Mercedes-Benz

Campaign No. 2019100006, October 2019

SUBJECT: **Model 907 (Sprinter), Model Year 2019
Screw Connection Hood Catch**

D88.40-1130-06

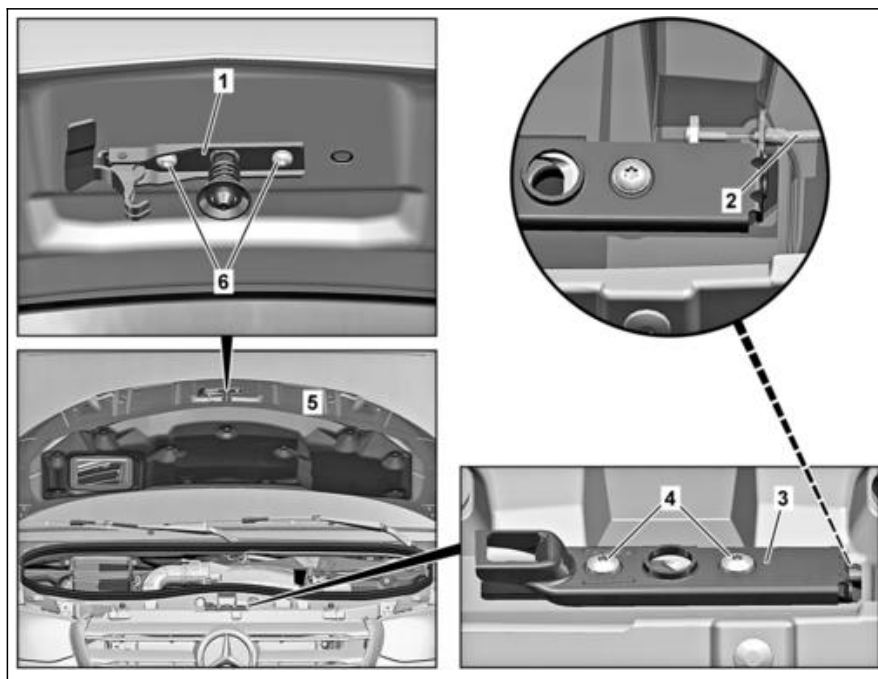
Daimler AG (“DAG”), the manufacturer of Mercedes-Benz and Freightliner Sprinter vans, has determined that, the screw connection on the upper hood catch of certain Mercedes-Benz and Freightliner Sprinter vehicles (VS30; Platforms 907) may not have been carried out according to specification. Depending on vehicle speed, wind resistance, aerodynamic drag and factors such as vehicle loading and road conditions, the hood could open while the vehicle is being operated. If the hood were to open while driving, it could impact the driver's field of vision, thereby increasing the risk of a crash. An authorized Mercedes-Benz or Freightliner Sprinter dealer will check and if necessary tighten the torque of the screw connection. Any missing screws will be replaced if necessary.

2	Check whether the screws (6) are present.	If a screw (6) are not present, ↓ screw in missing screw (6) subsequently by hand.	
Retighten Screws			
3	Retighten screws (6).	Bolt, upper section of hood catch to hood	BA88.40-N-1003-01TS

Number	Designation	Model 907
BA88.40-N-1003-01TS	Bolt, upper section of hood catch	8Nm
